MAG-9000 Body

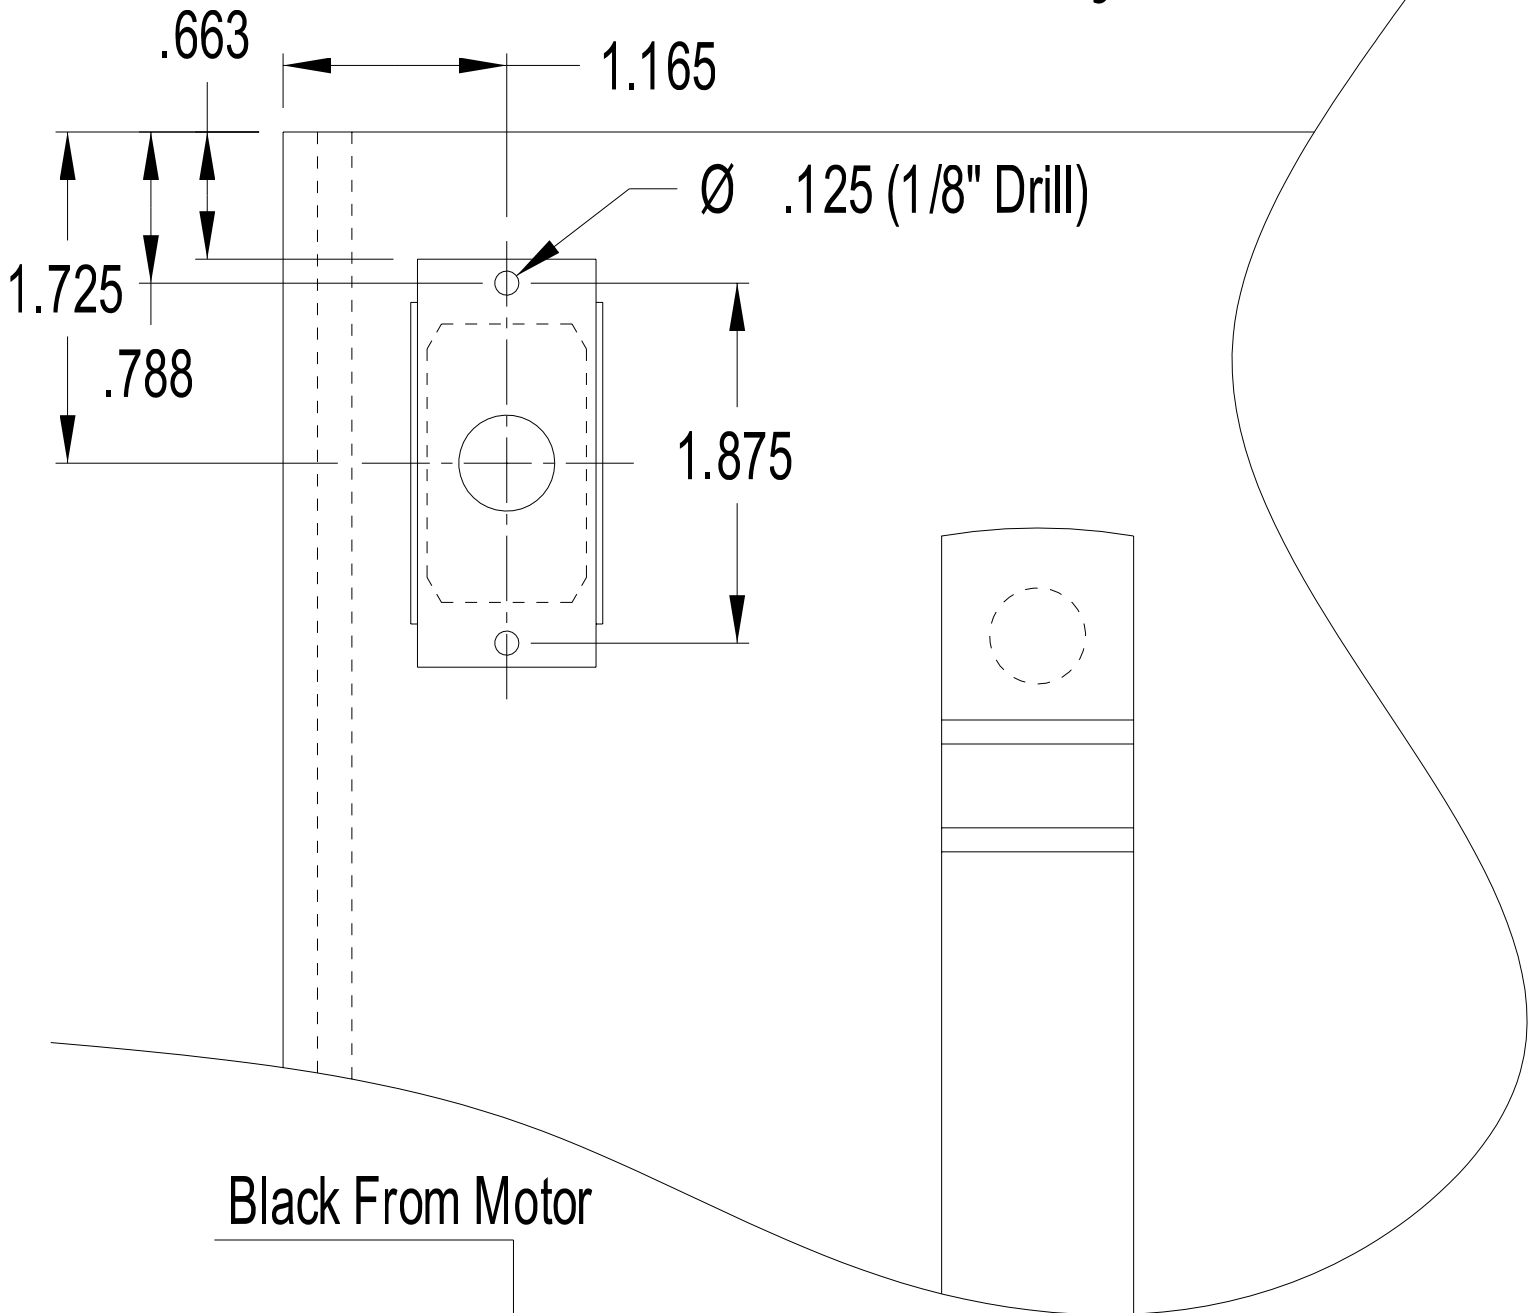
Old Red Line was for the Light in the Lit Rocker Switch and should be removed from the capacitor.
